**BEFORE THE CANTERBURY REGIONAL COUNCIL**

**IN THE MATTER** of application CRC190445 by Christchurch City Council to  
discharge stormwater to land and water

**JOINT STATEMENT OF WATER QUANTITY WITNESSES**  
**5 FEBRUARY 2019**

Figure 1 Lower Styx Water Level Record Showing a Limited Number of Years

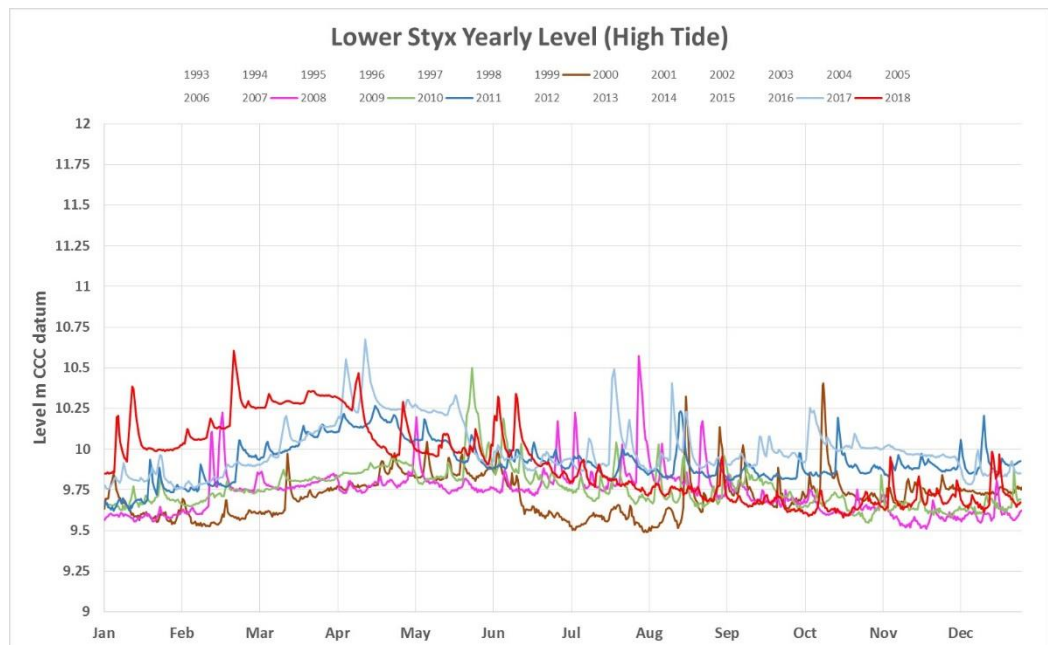
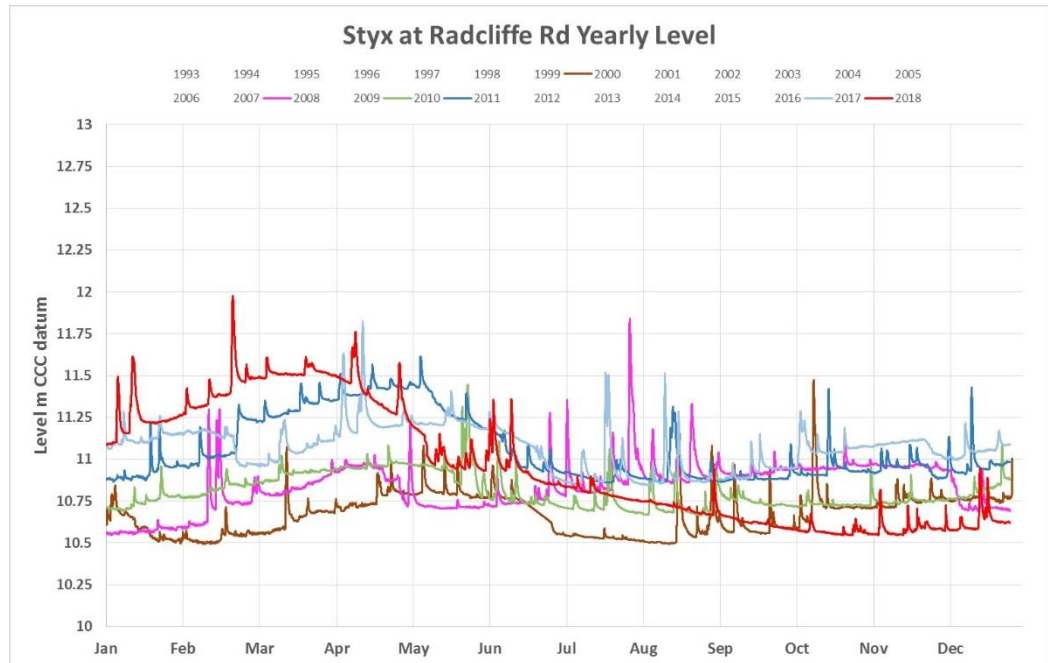
- 28 The low flow water level in advance of the August 2008 event as measured at Radcliffe Road and Lower Styx Road was not extreme (Figure 1 and Figure 2) and it is likely that the weed condition at the time was within the normal range (as inferred from the water level records).

Figure 3 Lower Styx Water Level Record Showing All Years

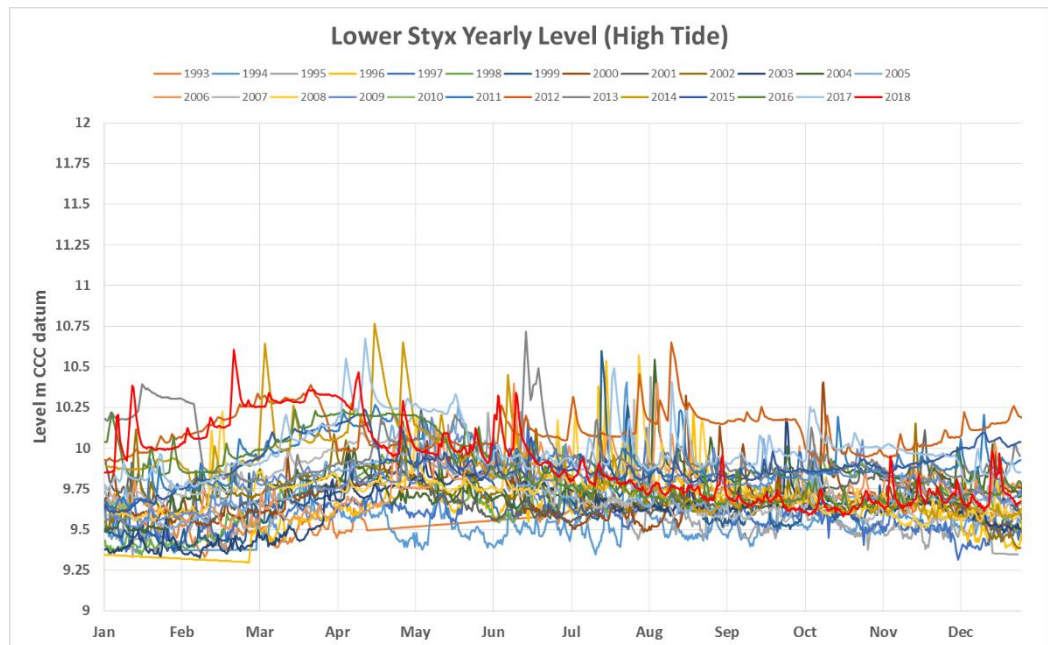
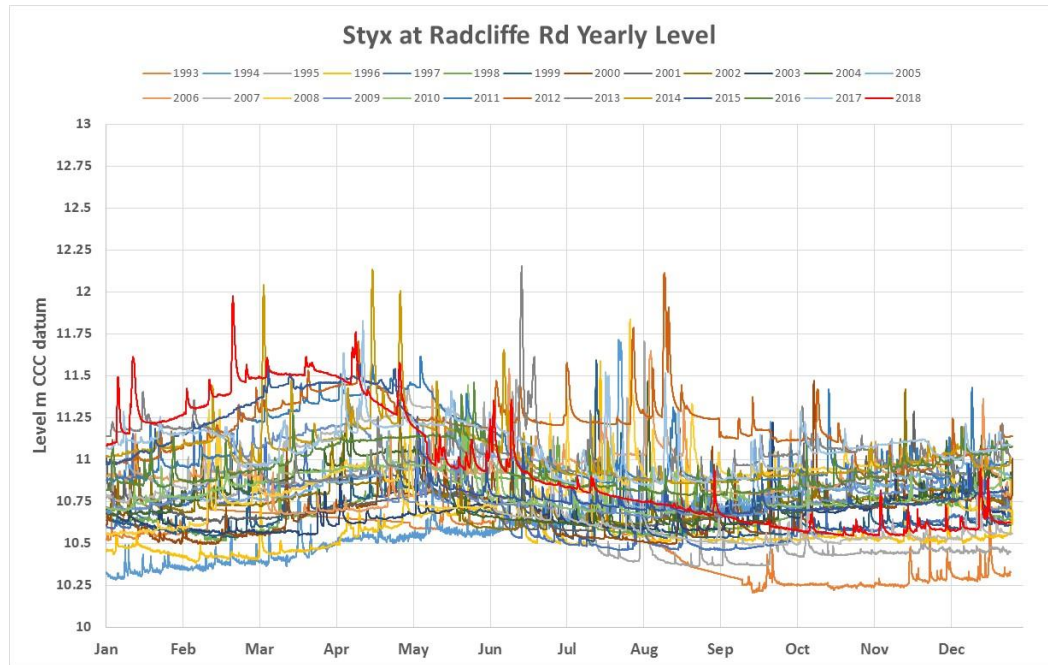
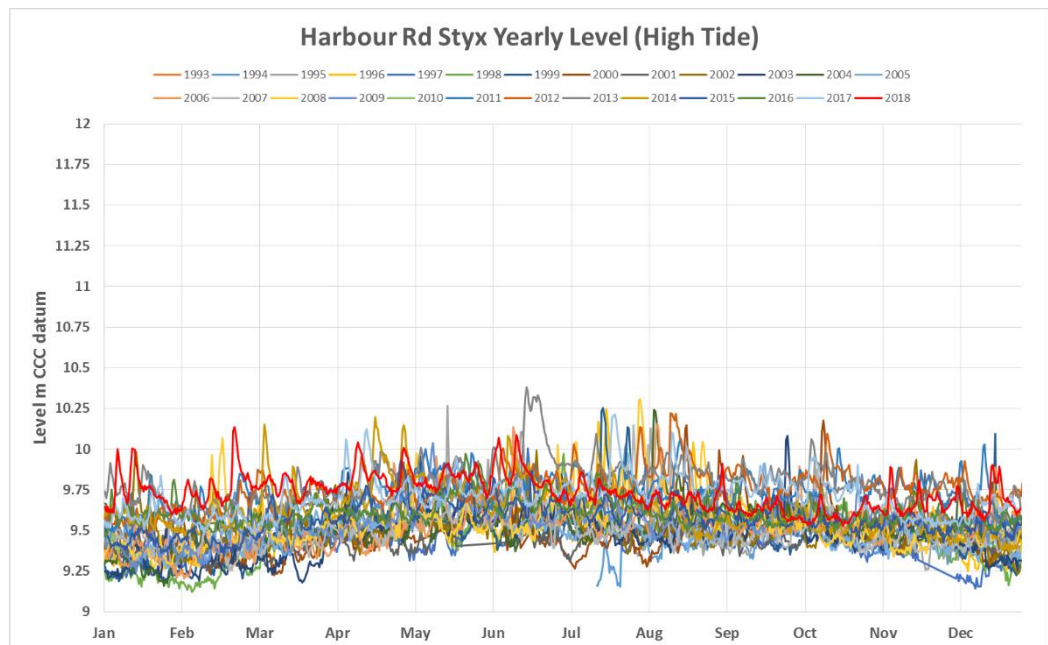
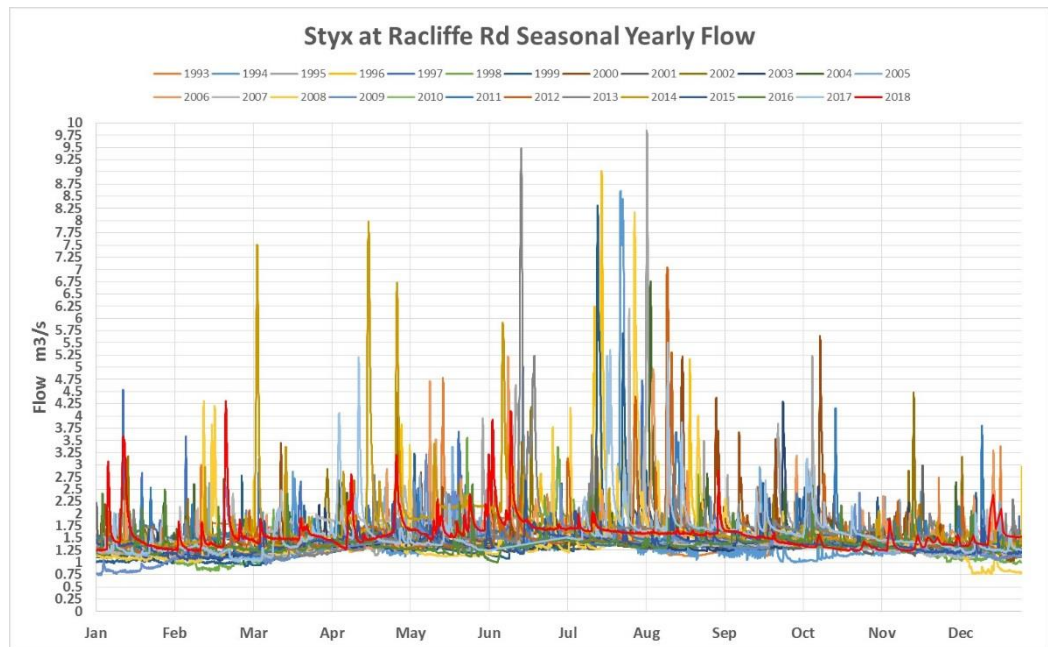
- 29 There is considerable variability in recorded low flow water levels at the Lower Styx (Figure 3) and Radcliffe Road (Figure 4) sites and much less variability at the Harbour Road (Figure 5) site. The flow record at Radcliffe Road (Figure 6) indicates that the variability in water levels at low flow is dominated by the weed condition rather than the flow rate. The water level variance at Radcliffe Road has been observed at up to 1 m, whereas is it approximately 0.5 m at Harbour Road. For the purposes of this response to Minute #4 and #5 the description of river management and channel maintenance is limited to weed harvesting, given the overwhelming significance of weed management.

Figure 8 2011 LiDAR survey data (overland flow paths shown with red arrows and Bakers Drain shown in blue)

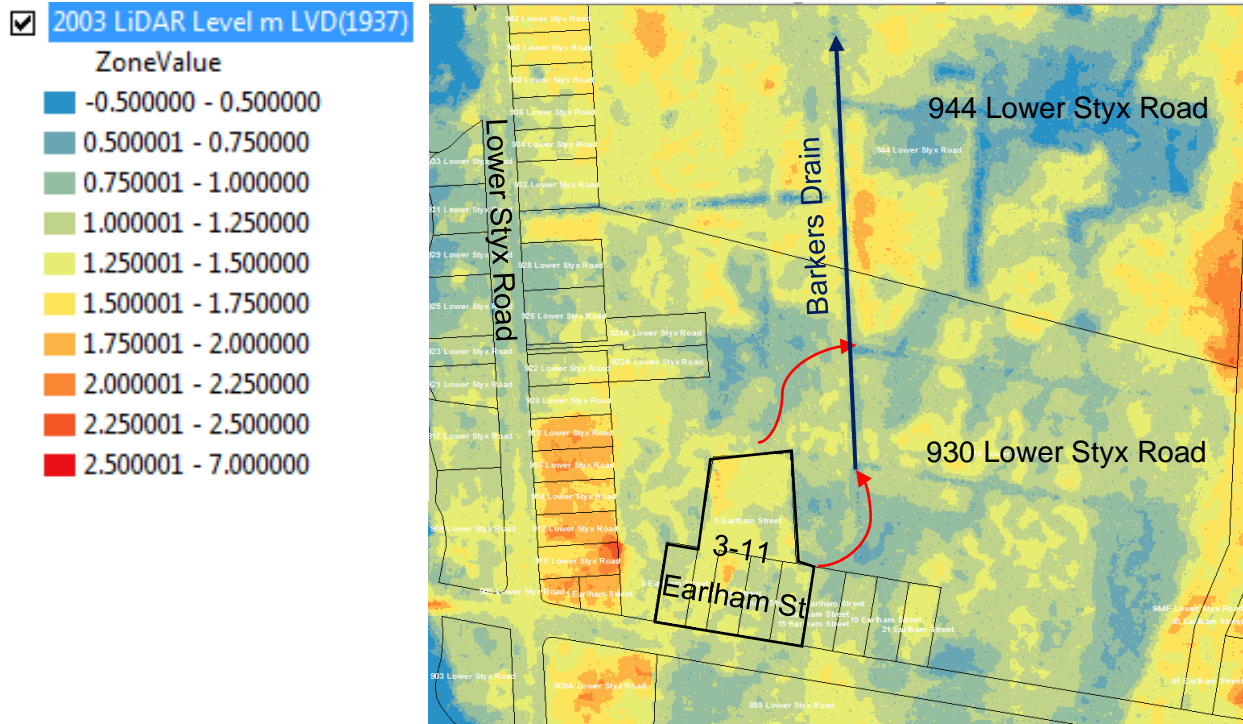
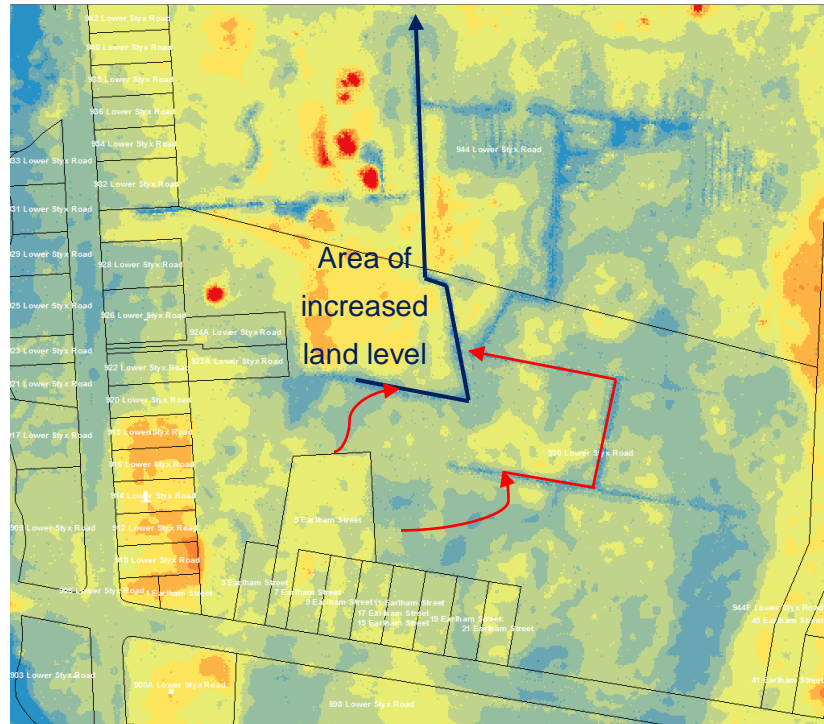
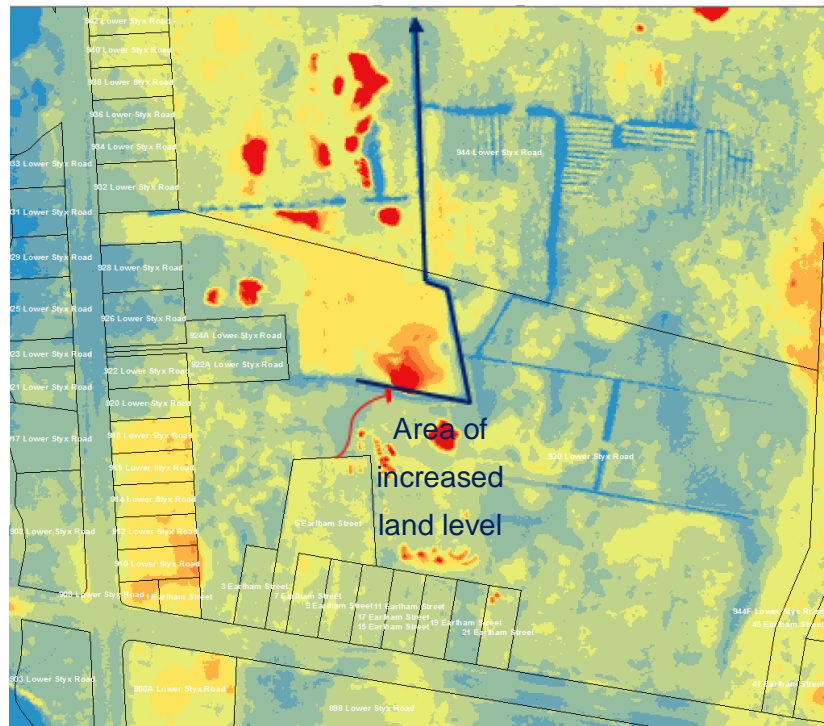
- 50 There appears from aerial laser survey data (LiDAR) that the land surface has changed between 2011 and 2015 in and about the head of Barkers Drain (Compare Figure 8 and Figure 9 where lower levels are shown in blue and higher levels are shown in red). This is assumed to be filling.

- 51 The 2011 LiDAR shows the realignment of Barkers Drain about the dwelling located at 930 Lower Styx Road (Figure 8) and with an area now showing in yellow / orange / red colours representing the new building platform. It also appears that there has been some reshaping of the other field drains within the property, presumably as a result of earthworks rather than natural processes. This has resulted in a lengthening of the eastern flow path connecting with the drain. Given the flat nature of the terrain it is likely that this has reduced the effectiveness of the drain, however, it appears that the resulting ponding is likely to principally occur on 930 Lower Styx Road. The depths of ponding upstream of the drain are similar to that experienced prior to the earthquakes but soakage to ground will be impeded due to the overall lowering of the ground in the area.

- 52 Further land surface change at 930 Lower Styx Road is evident in the 2015 LiDAR data (Figure 9). The survey indicates that the primarily overland flow path away from 3 – 11 Earham Street has raised, likely to be as a result of filling. This could result in ponding on both 930 Lower Styx Road and on the Earham Street Properties. This ponded depth may be up to 250 mm (noting the LiDAR accuracy of +/- 100 mm). Generally, the LiDAR indicates that drainage of the properties at 3 – 11 Earham Street appears impeded by the change in land surface within 930 Lower Styx Road.
- 53 The discharge of stormwater from the roofs of the new buildings in Earham St could also have added to the ponding of surface water as this point discharge would not soak away when the groundwater is high.

- (a) Filling of land adjacent to the Earlham St properties is likely to have increased the extent and duration of ponding of water to the Earlham St properties.
- (b) The situation could be improved by constructing a channel through the filled area to Barkers Drain.
- (c) Recommend that CCC instigates the restoration of the natural flow pattern using a channel as in (b)
- (d) Groundwater levels are closely related to Styx River levels in the Lower Styx area and at times of elevated river levels, groundwater could be above the ground surface in lower lying areas

Figure 10 Groundwater data at Dartford Street

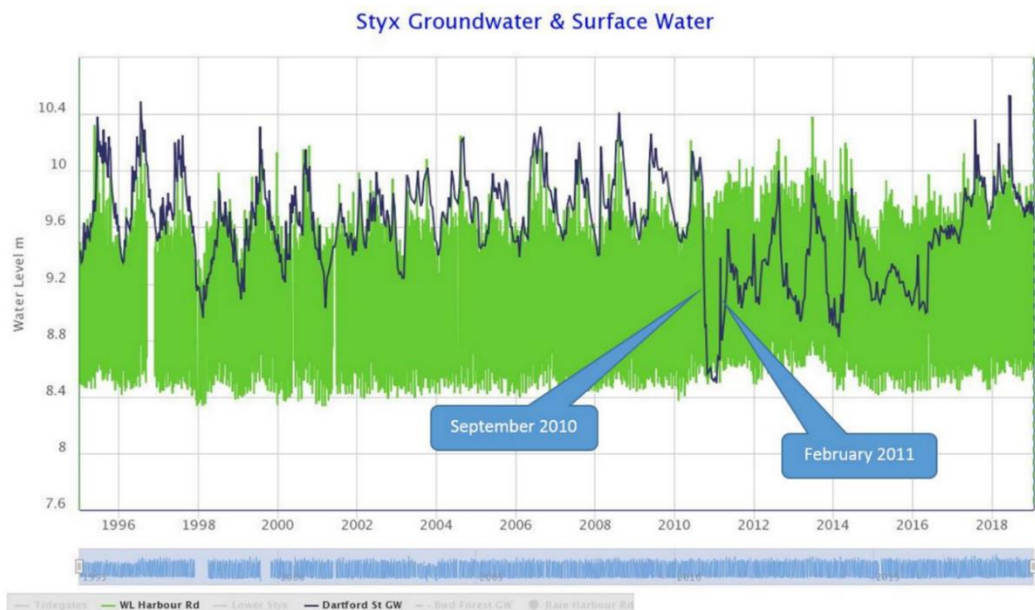
- 56 The graph below (Figure 10) shows the groundwater level since 1995 at Dartford St in Brooklands (black line) and the Styx River water level at Harbour Rd (Green). The range of the green band indicates the tidal

- 57 It is evident that there is a strong correlation between the seasonal water levels at Harbour Rd and the groundwater level measured at Dartford St. This correlation was interrupted and groundwater levels dropped when the first earthquake hit in September 2010 and there is also a mild groundwater response to the February 2011 when the second earthquake struck. Groundwater levels have however remained about 400mm lower than normal up until about 2015 and have gradually recovered to their normal level in about 2017 when once again the correlation with the Styx River level at Harbour Rd has been re-established. It is possible that there has been a similar effect in the Earlham St area however, since the ground has also settled by perhaps 200 to 300 mm at the time of the earthquake, the initial perception would be that the groundwater levels are similar to the pre-earthquake levels however now that the groundwater levels have recovered they will perhaps appear much higher than previously and be visible above the ground surface more frequently and for longer periods.
